1963 - 1967 Corvette: Service News: Corvette Coupe Body Rework for Larger Racing Tires (Rear Wheels)

Model and Year: 1963 - 1964 Corvette

Source: Chevrolet Service News

Date: August 1964, Volume 36, Issue Number 7

Fig. 2—Rework of 1963-64 Corvette Model 837 for Installation of Larger Tires

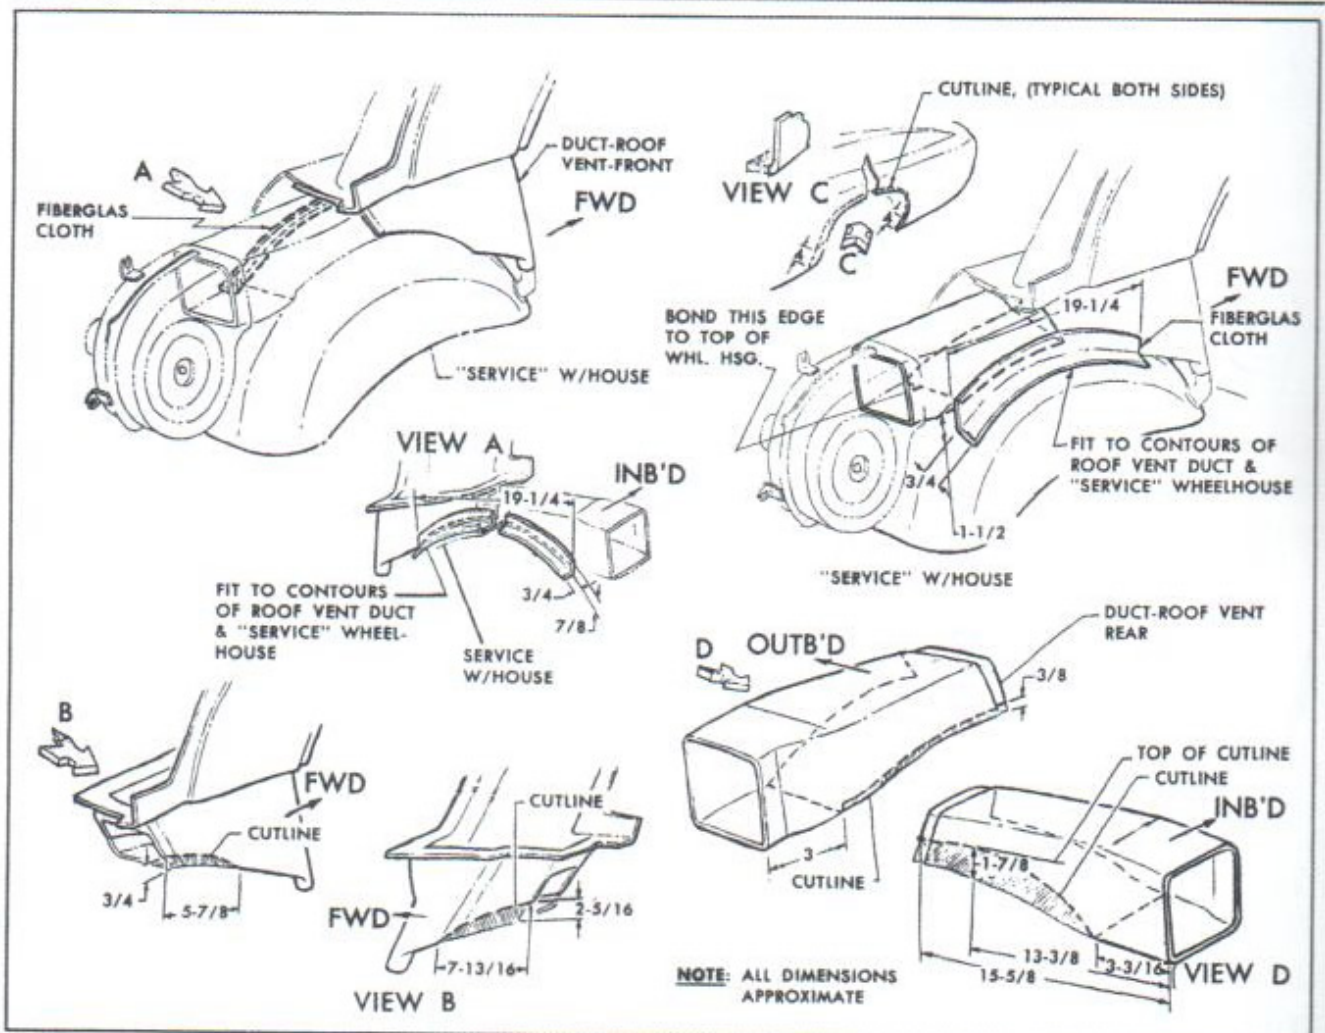
On closed models, adequate wheel travel clearances may be obtained for 7.10-7.60 x 15 tires mounted on RPO P48 Aluminum Knock-off Wheels (6" rim width) by installing the inner wheel housings which are used in Production with the RPO N03 fuel tank of 35 gallon capacity, and by cutting material away in the wheel openings. These wheel housings are serviced under P/N's 3794441 and 3794442 for the right and left sides respectively. On the left side, considerable rework is required to make the larger wheel housings fit under the body rear compartment air exhaust duct. Individual owners may elect to have the exhaust duct system removed instead of going to the expense of the rework. If the rework is undertaken, the efficiency of the rear compartment air exhaust system will be decreased because of the reduced duct area just over the wheel housing.

Refer to Figure 2 for details of the installation of the larger wheel housings, the provision of extra clearance between the tire and wheel openings, and the

modification of the body rear compartment air exhaust duct. In those areas where cutting and rebonding of fiberglass is involved, regular shop practices and materials should be used. The use of the materials show in Group 12,800 of the Chevrolet Parts Catalog is suggested.
